SB-GA8-2005-31

Service Bulletin

Installation of parachute options/modifications.

GA8 and GA8-TC 320 all serial numbers.

Figure 2: Location of the Holes on the Roof.

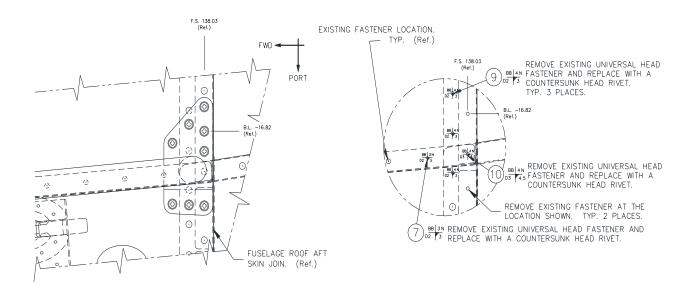
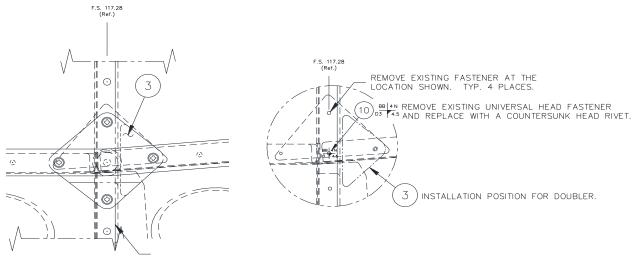
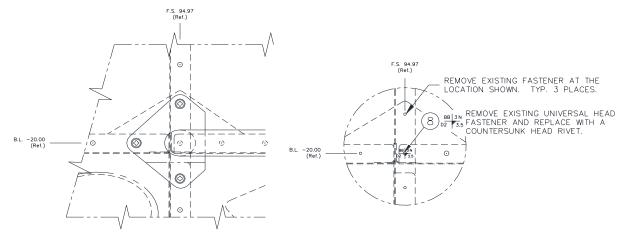
- 1.1. Remove the interior panels in the vicinity of the door to gain access to the structure, see Service Manual.
- 1.2. Locate and remove the appropriate rivets in the roof structure, figure 2 and 2a, 2b, 2c.

- 1.3. As appropriate reinstall countersunk rivets as per figures above (Items 7, 8, 9 and 10).
- 1.4. Locate the parachute handle over the remaining holes and drill through the handle Ø0.169. Secure handle by placing a bolt in the first hole in each attachment point to maintain alignment.
- 1.5. Deburr the holes and install the handle using the hardware specified (items 4, 5 and 6). Ensure item 3, doubler is fitted under the middle attaching point (figure 2b).
- 1.6. Reinstall the panels and install the door handle as per figure 3.

Figure 4 Static Line Lock

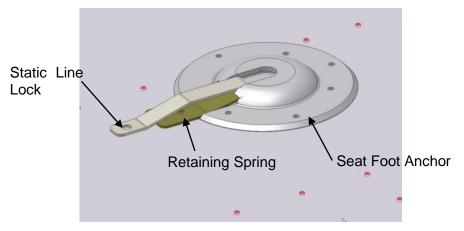
- 2.1. Position the Static Line Anchor into the seat fittings. See Flight Manual supplement C01-04-58 for the correct locations.
- 2.2. Position the Static Line Lock, item 16 such that the upright leg is between the static line foot and the retaining spring. See Figure 4.

Figure 5: Wind Deflector Foot Location

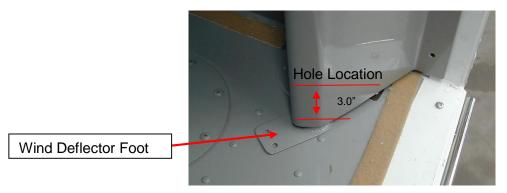
- 2.3. Mark the centre of the hole in the safety lock onto the floor and drill a Ø0.25" hole in the floor. Notch the hole using a rattail file or similar to provide a keyway for the rivnut.
- 2.4. Using the correct rivnut installation tool install Item 8 in the floor ensuring alignment of the rivnut key lock with the key way.
- 2.5. Repeat steps 2.2 to 3.4 for the other end of the static line anchor.
- 2.6. Position the wind deflector foot, Item 7, in the wind deflector and install the wind deflector in the aircraft. Position the foot flat on the floor, clear of all rivet heads. See Figure 5.

- 2.7. Measure up from the floor 1.5" and 3" along the wind deflector and drill a Ø0.125" hole at each height such that the drill passes through the deflector and the footspring where the steel foot is hard against the deflector.
- 2.8. Apply a liberal quantity of Duralac or similar joining compound to the faying surface and rivet the foot to the deflector using item 9.
- 2.9. With the deflector in place mark the location of the holes in the foot on the floor. Remove the deflector and drill the floor Ø0.25. Notch the hole using a rattail file or similar to provide a keyway for the rivnut. Using the correct tool install item 8 ensuring alignment of the rivnut key lock with the key way.
